SAN FRANCISCO UNIFIED SCHOOL DISTRICT  
2011 PROPOSITION A BOND PROGRAM  
VISITACION VALLEY MIDDLE SCHOOL

**INTERIM HOUSING & MODERNIZATION ADDENDUM NO. 1**

**PROJECT:** Visitacion Valley Middle School  
450 Raymond Ave., San Francisco, CA 94134

**DATE:** March 11, 2015

| SHEET NO.<br><b>ADD1<br/>FA3.03.1</b> |                                 | ARCH. JOB#<br>13050 |

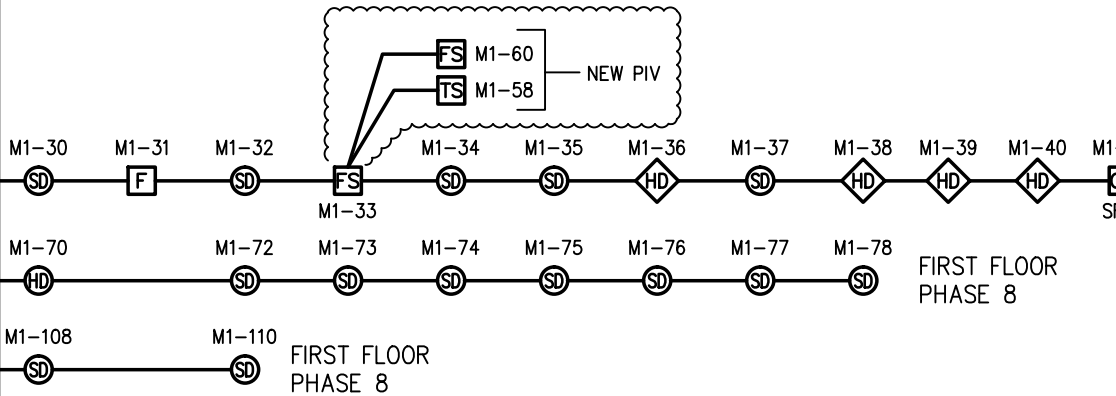
Description: Add fire monitoring connection to new PIV location on riser diagram. See sketch ADD.1 FA3.01.1.
